**RE: Field Issue of embedded holdown device omitted for Lot #13 Cobey creek – 537 SE Carter Rd.
Lee's Summit, MO 64082 – Permit # PRRES20220859**

FIGURE R602.10.6.2 METHOD PFH—PORTAL FRAME WITH HOLD-DOWNS

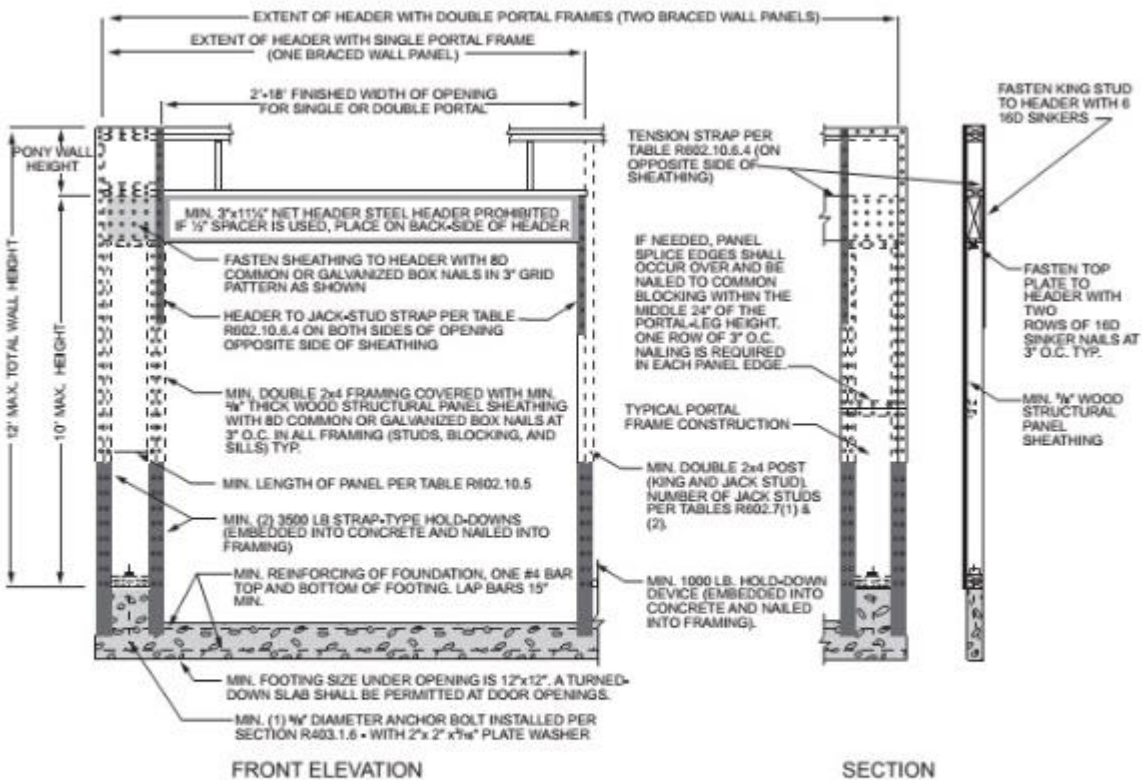
- One 3500# embedded strap holdown was omitted for PFH portal frame at 16' garage door opening:

- Install PFH at garage per IRC figure as shown in image above.
- Install HDU8-SDS2.5 at omitted embedded strap location per manufacturer's spec's.
- HDU8-SDS2.5 shall be drilled and epoxied into foundation wall at 6" depth.
